HOSHIZAKI AMERICA, INC.

SERVICE BULLETIN

SB21-0007

Subject: Bin control design change on large KM “M” series units

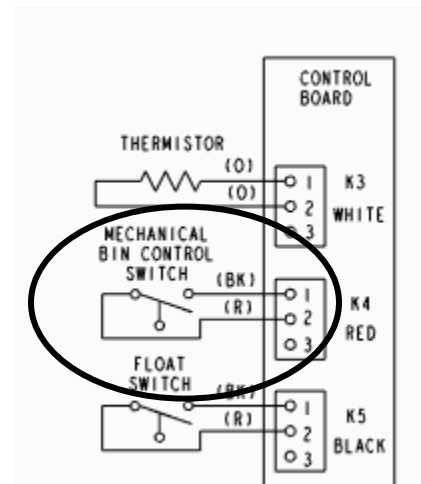
The bin control has been changed on the large “M” model KM series units. The previous thermostatic bin control 4A2879-02 has been replaced with the mechanical bin control 2A8598G01.

This change also includes a change in wiring. Please see the samples below for examples of the change.

(Previous thermostatic bin control wiring)

(New Mechanical bin control wiring)
